<b>DOCKETED</b>	
<b>Docket Number:</b>	23-AFC-01
<b>Project Title:</b>	Morton Bay Geothermal Project (MBGP)
<b>TN #:</b>	258995
<b>Document Title:</b>	Comments of the California Unions for Reliable Energy on the Preliminary Staff Assessment
<b>Description:</b>	Comments of the California Unions for Reliable Energy on the Preliminary Staff Assessment with Attachments A-H
<b>Filer:</b>	Alisha Pember
<b>Organization:</b>	California Unions for Reliable Energy
<b>Submitter Role:</b>	Intervenor
<b>Submission Date:</b>	9/4/2024 4:44:13 PM
<b>Docketed Date:</b>	9/4/2024

MORTON BAY GEOTHERMAL  
PROJECT APPLICATION FOR  
CERTIFICATION

**COMMENTS OF THE CALIFORNIA UNIONS FOR RELIABLE ENERGY**  
**ON THE PRELIMINARY STAFF ASSESSMENT**

**Figure 4:** Wind Rose Plot Illustrating Wind Conditions at Sonny Bono Monitoring Station

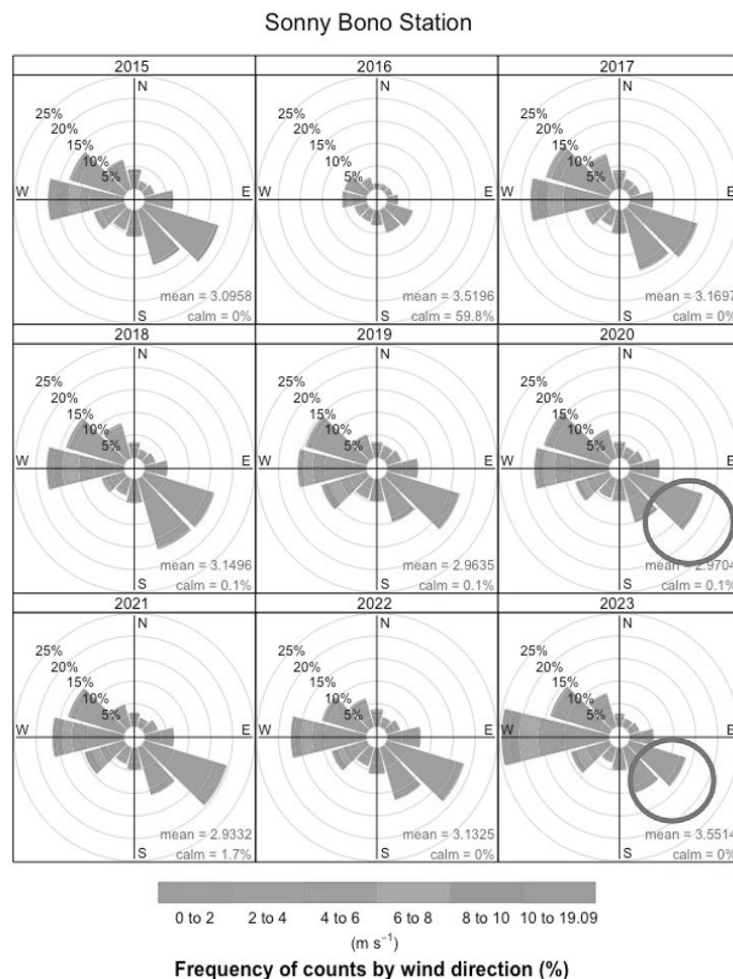
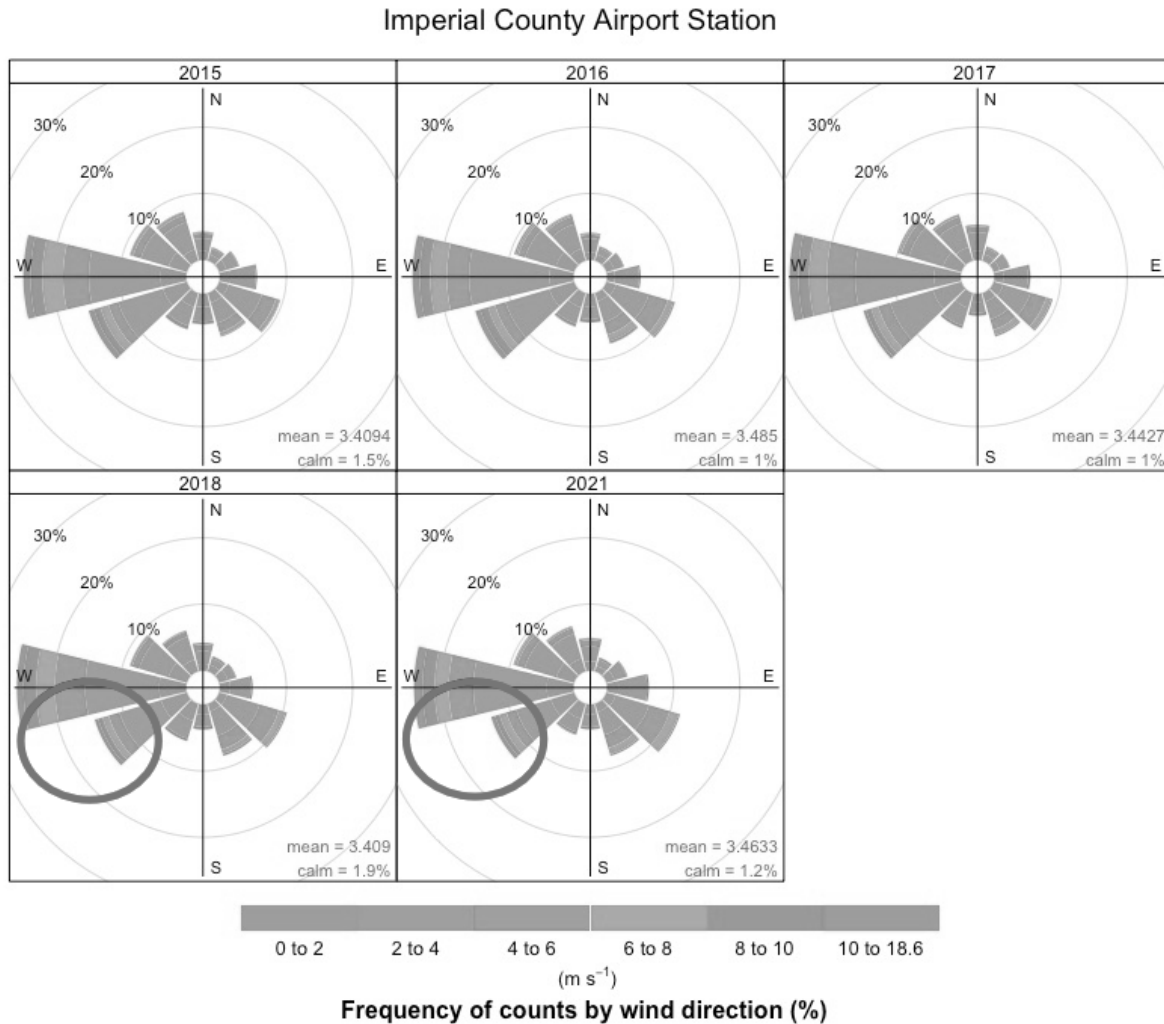
- **Wind Rose Comparisons in Assessing Local Wind Patterns:** The Applicant's comparison of wind roses from the Imperial County Airport and the Sonny Bono station is flawed. The Imperial County Airport data indicates predominantly westerly and southwesterly winds (Figure 4), while the Sonny Bono station data indicates predominantly southeasterly winds (Figure 5). This substantial discrepancy in wind direction further demonstrates why the Imperial County Airport data is not representative of the project site. Wind roses provide a broad overview of wind patterns but do not capture the full range of local atmospheric dynamics. Relying solely on wind rose comparisons overlooks other critical factors such as temperature, humidity, and atmospheric stability, which can significantly impact dispersion modeling.

**Figure 6:** Map Illustrating the Location of the Project's Switching Station

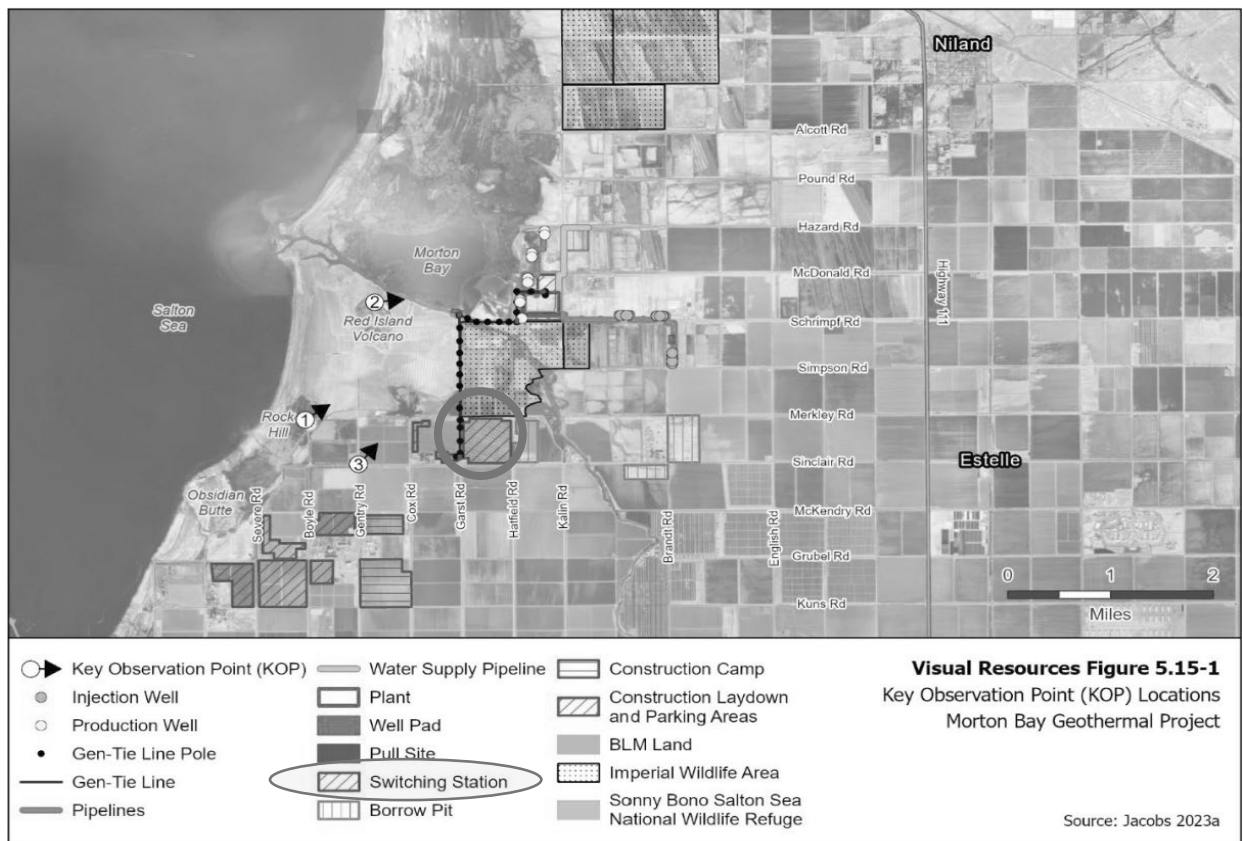
The PSA exclusion of emissions from the switching station's construction are problematic. They justify this omission by citing the station's smaller footprint<sup>16</sup>, lower ground disturbance, shorter construction duration, and fewer pieces of equipment, while also claiming similar receptor distances and the implementation of mitigation measures AQ-SC1 through AQ-SC5.

**Figure 4: Wind Rose For Imperial County Airport**

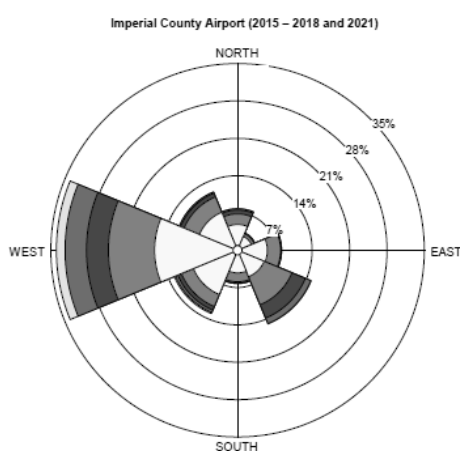
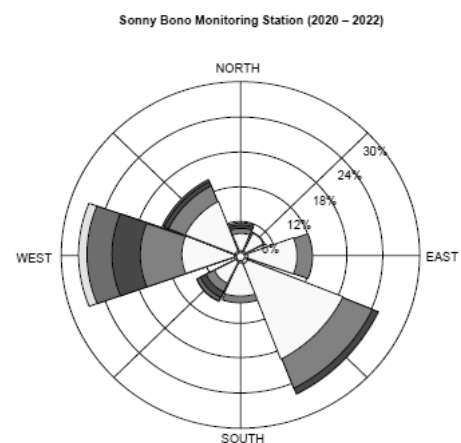
The Project Site is located directly adjacent to the Salton Sea, but the Imperial County Airport NWS station, which provides the meteorological data used in the current model, is 28 miles south of the Project area. However, this approach may not accurately reflect the conditions at the Project site. As a large body of water, the Salton Sea creates a differential heating effect compared to the surrounding desert, leading to variations in wind speed. This can be seen when the wind data from the Imperial County Airport NWS station is compared to the Sono Bono Monitoring Station data.

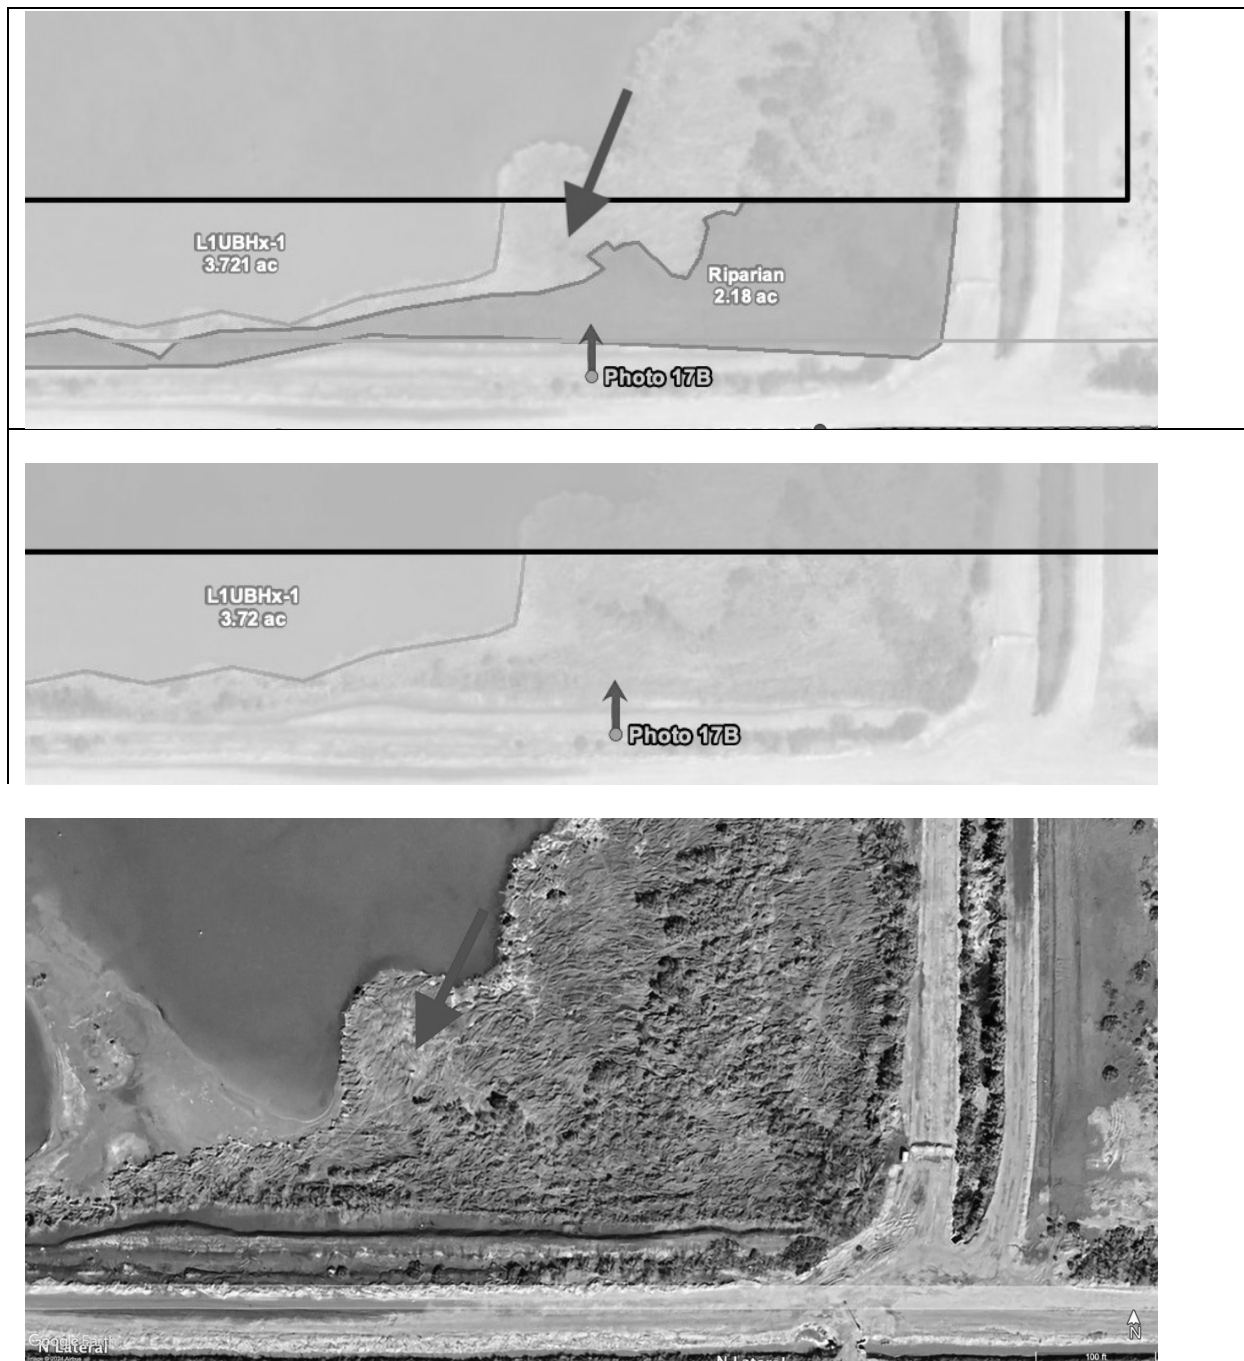
- 5) There is no explanation for why some of the wetland vegetation that borders Schrimpf Road Cove was not delineated as a jurisdictional feature in TN 249725 (Figure 2, below). Notably, no wetland sampling was done at this location to justify the delineation.

Woodland and Shrubland along Garst Road (and all other areas that contained hydrophytic vegetation and hydric soils) should have been delineated as a wetland.

**Figure 3. Hudson Ranch New Well 13-4 Project site (left image) in relation to Project borrow pit (right image). Red arrow points to northwest corner of the parcel for reference.**

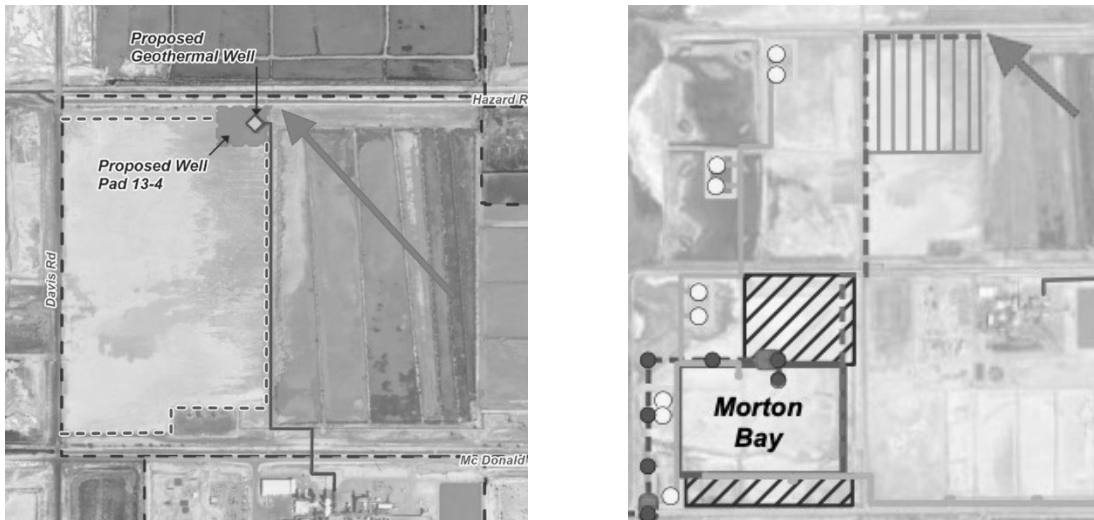
The Energy Source Mineral ATLAS Project is located immediately adjacent to the Project’s laydown and parking area southwest of the intersection of McDonald Road and Davis Road.<sup>146</sup> The Hudson Ranch New Well 13-4 Project coincides with the Project’s proposed borrow pit southeast of the intersection of Hazard Road and Davis Road (Figure 3, below).<sup>147</sup> The Shared PowerCo 1 and Lithium Co 1 Facility for the Hell’s Kitchen Project is located approximately 0.55 miles north of Project’s northernmost well pad (for production wells MB-08 and MB-09).<sup>148</sup> In addition, a portion of the gen-tie line for the Hell’s Kitchen Project would overlap with the proposed Project’s fresh water line. At a minimum, the following projects are located close enough to the proposed Project that they could contribute to cumulative noise impacts: (1) Energy Source Mineral ATLAS Project, (2) Hudson Ranch New Well 13-4 Project, (3) Hudson Ranch Power Plant (existing), (4) Hell’s Kitchen Project, (5) Elmore Geothermal Project (existing), (6) Cal Energy Generation Project (existing), (7) Vulcan Power Plant (existing), (8) Elmore North Geothermal Project, and (9) Black Rock Geothermal Project. The PSA provides no analysis of how noise from cumulative projects would impact special-status animals in the Project area.

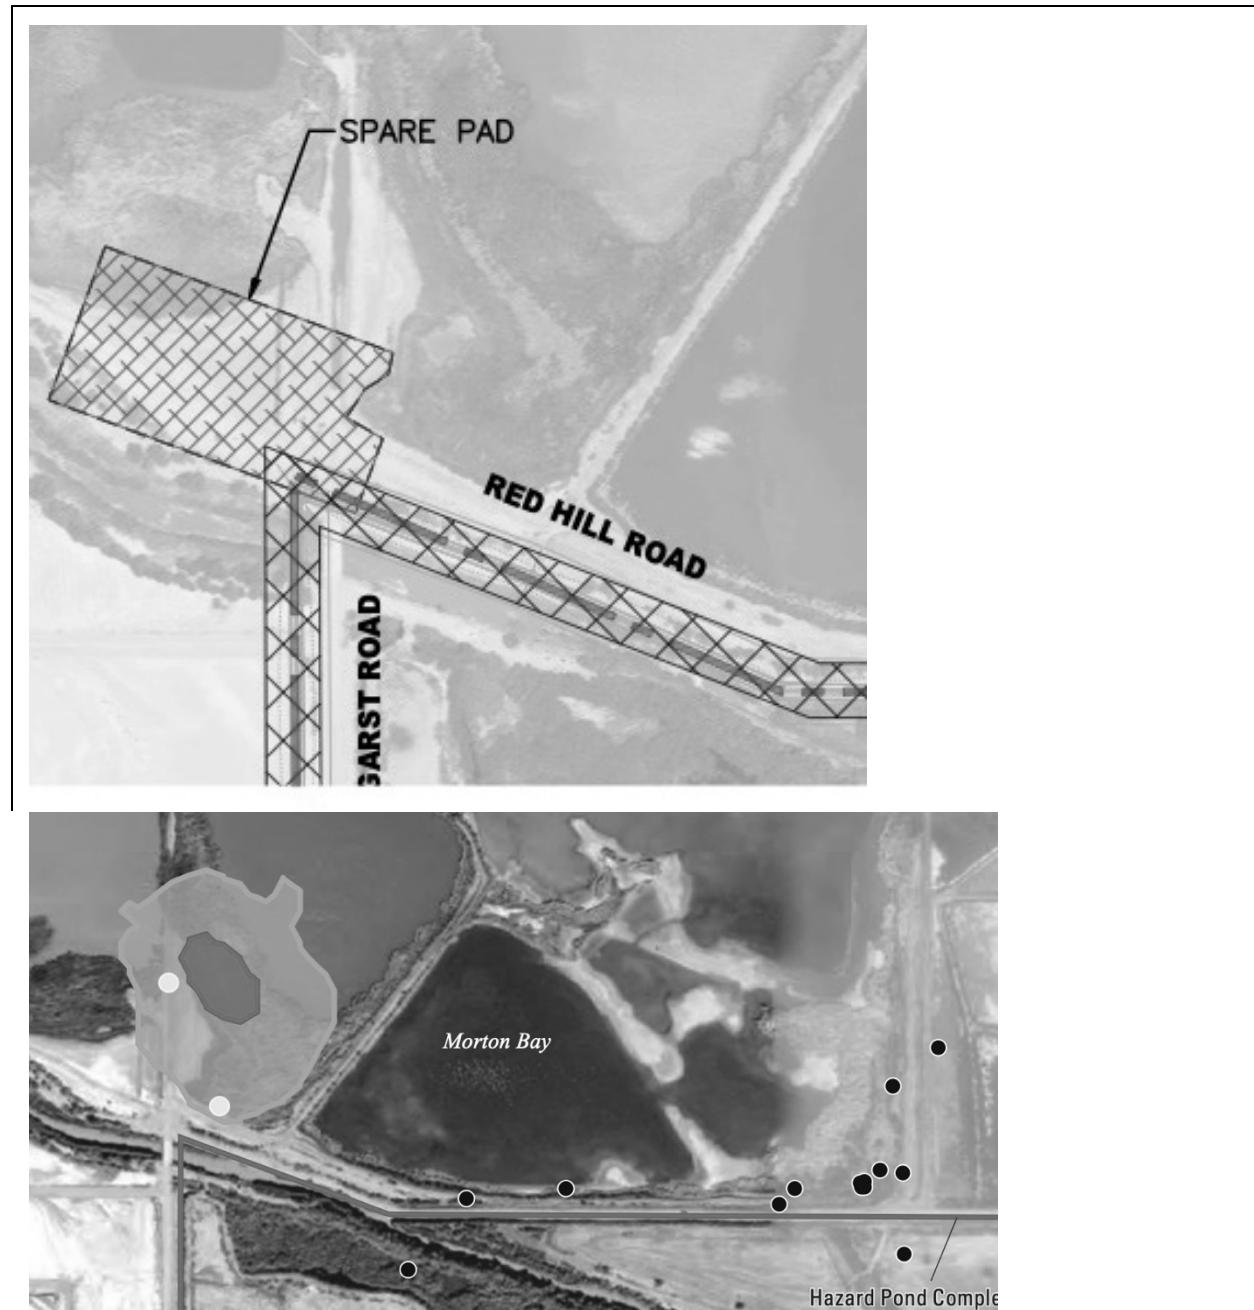
activities produce an hourly average noise level of 83 dBA, and because the drilling activities would be conducted in areas known to be occupied by Yuma Ridgway's rails, there is no apparent way for the Applicant to comply with the noise thresholds established in BIO-14 and avoid significant impacts to the subspecies.

**Figure 1. Site map showing location of plant and production wells circled in black (reproduced from MBGP PSA Figure 3.3)**

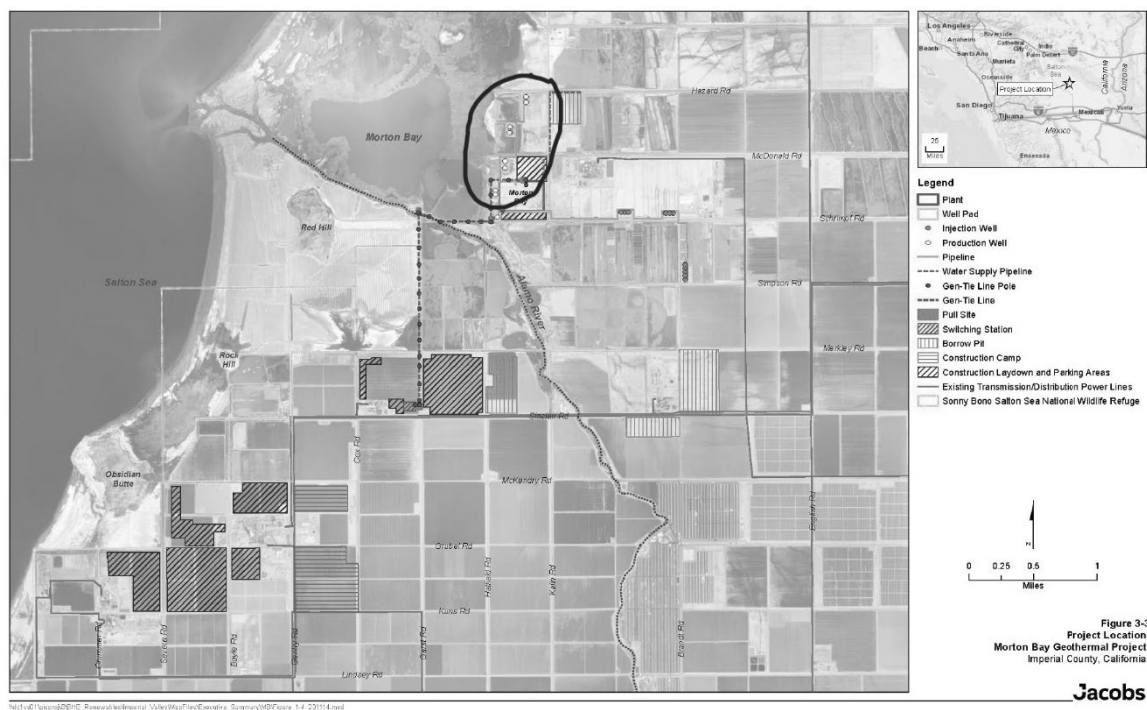
Project area soils where the production and injection wells and pipelines will be installed (see Figure 1) may be subject to erosion, expansion, and liquefaction from fluid leaks from pipeline infrastructure. The soils impacted by the MBGP are clayey, similar to those impacted by the Elmore North Geothermal Project and would be more prone to erosion due to soil structure degradation from heavy equipment during the project construction phase. High velocity fluids from a pipeline leak may cause soils in the vicinity of the pipeline infrastructure to liquify and undergo erosion in areas where soils were previously disturbed and degraded from construction activities. An analysis of the impacts from pipeline fluid leaks resulting in soil erosion is not included in the PSA and may be significant.
